66319B-521-01

S E R V I C E N O T E

66319B with Option #521

Reliability Improvement of Instrument

CORRECT J207 PLACEMENT – alignment to within $< 0.3\text{mm}$

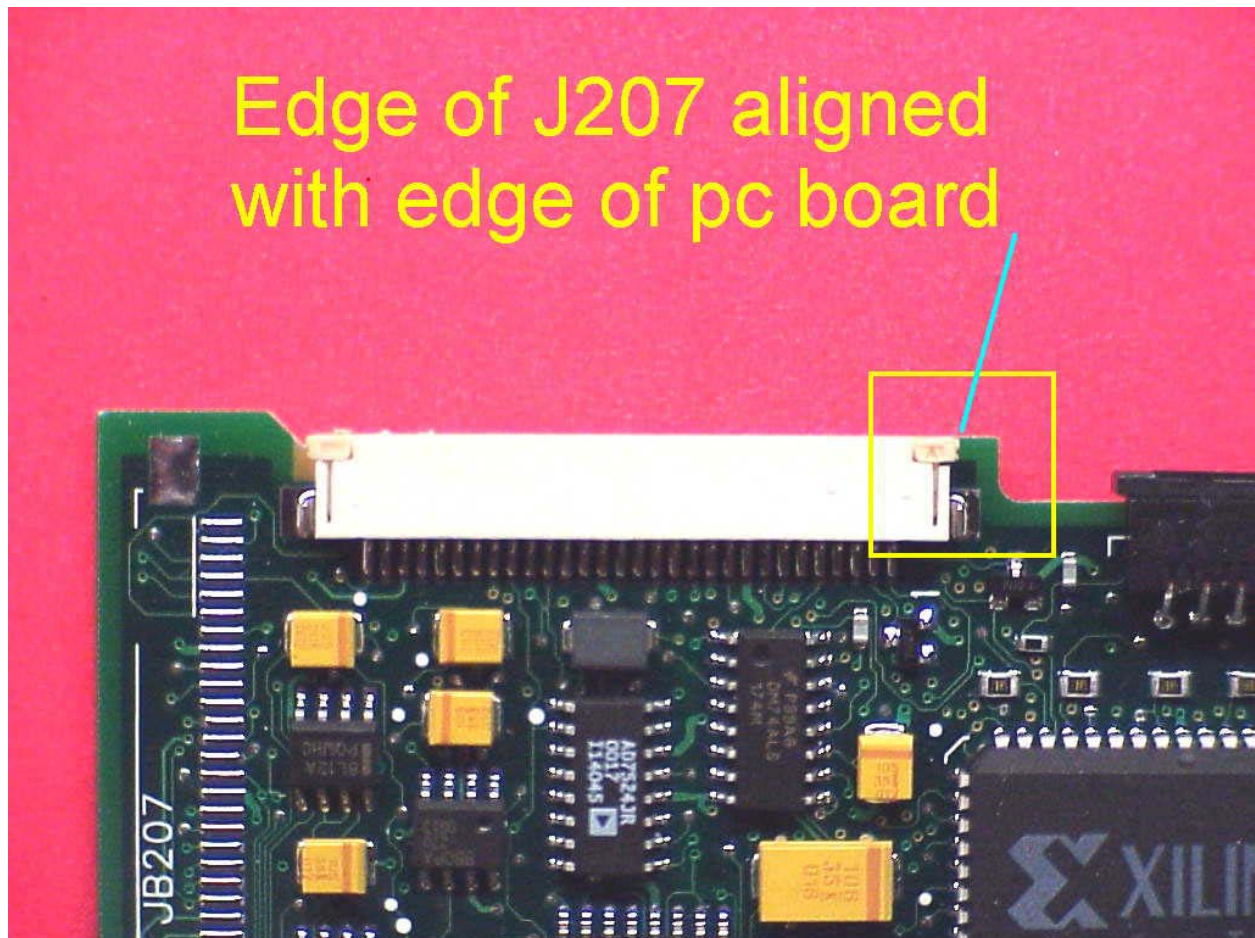
Latent product failure due to misplaced connector J207 on SMT assembly 5064-0018 (GPIB/RS232 interface). Misplacement of J207 could lead to inadvertent contact/shorting of exposed feed-throughs on SMT board. Ultimately, resulting in over-stress of components of damage to SMT board components. Resulting contact could degrade useful life of instrument.

Picture shows connector aligned to edge of SMT board to within $< 0.1\text{mm}$

- 1) Compare placement of J207 to attached photos. Instruments with a “misplaced” J207 should be returned to Agilent for warranty repair.
- 2) Instruments returned to the Service Center for routine calibration should be inspected for this potential defect. Defects should be addressed using Agilent’s unit exchange process with costs being charged to warranty.
- 3) The factory has modified production documentation to include visual inspection and specific electrical testing for this potential short.
- 4) Factory is maintaining feedback to SMT board supplier regarding quality of assembly.

INCORRECT J207 PLACEMENT – misaligned by $> 0.3\text{mm}$

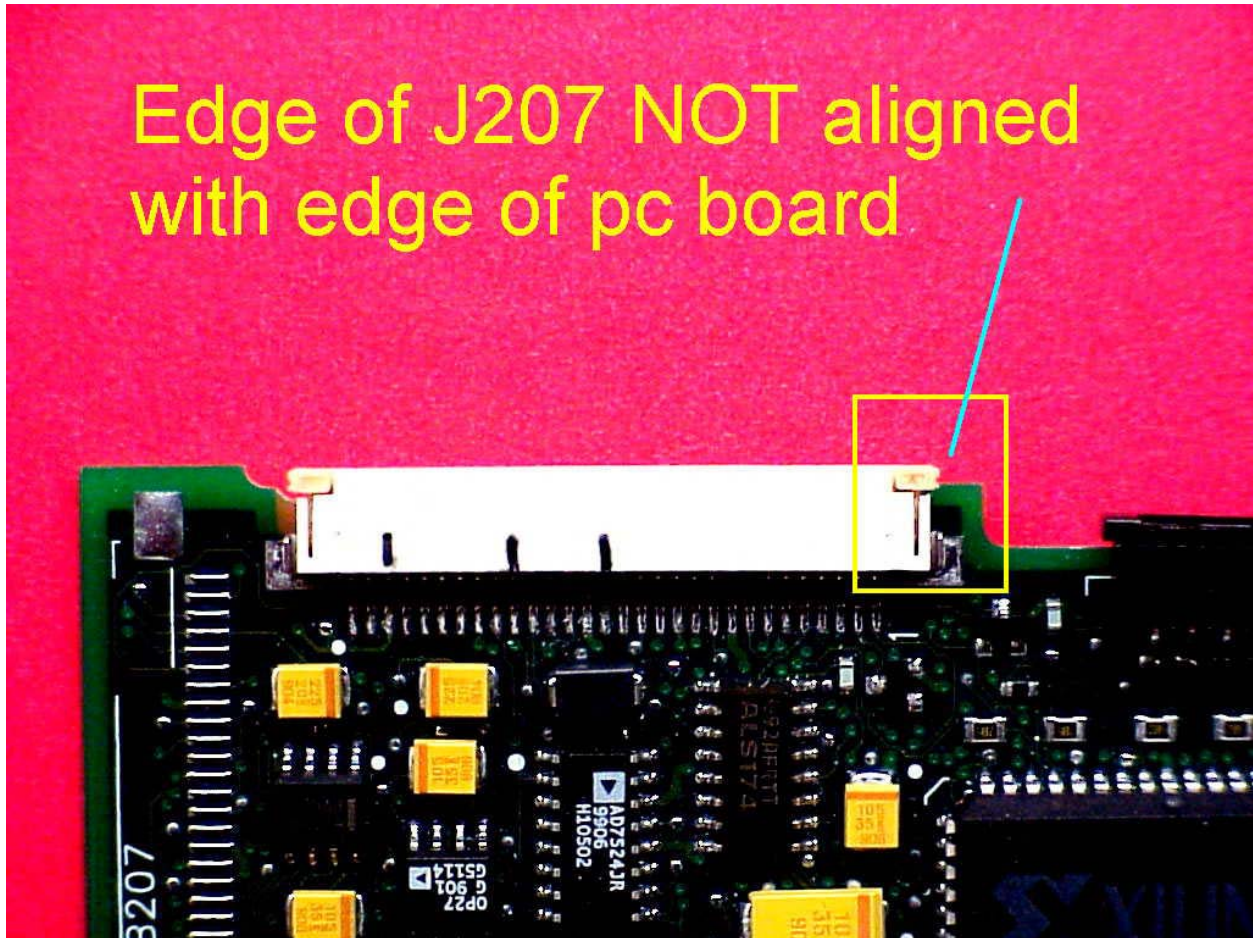
Picture shows connector extending past edge of SMT board by $>1.2\text{mm}$
